Intel[®] 82371AB PIIX4, Intel[®] 82371EB PIIX4E, Intel[®] 82371MB PIIX4M

Specification Update

January 2002

Document Number: [297738-017](#)

TD CONTROL AND STATUS (DWORD 1: 04-07h)

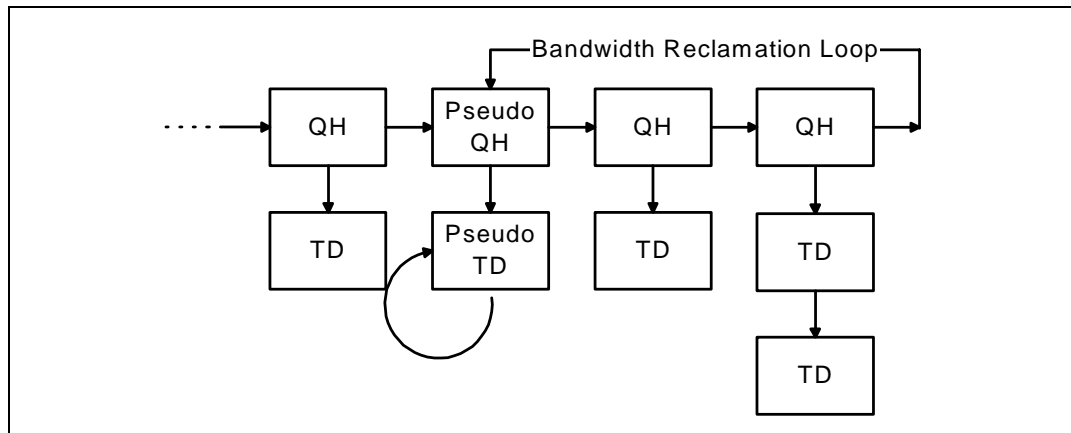
The Active status bit (bit 23) must be left unset at 0 indicating that the PIIX4/PIIX4E/PIIX4M should not execute this TD.
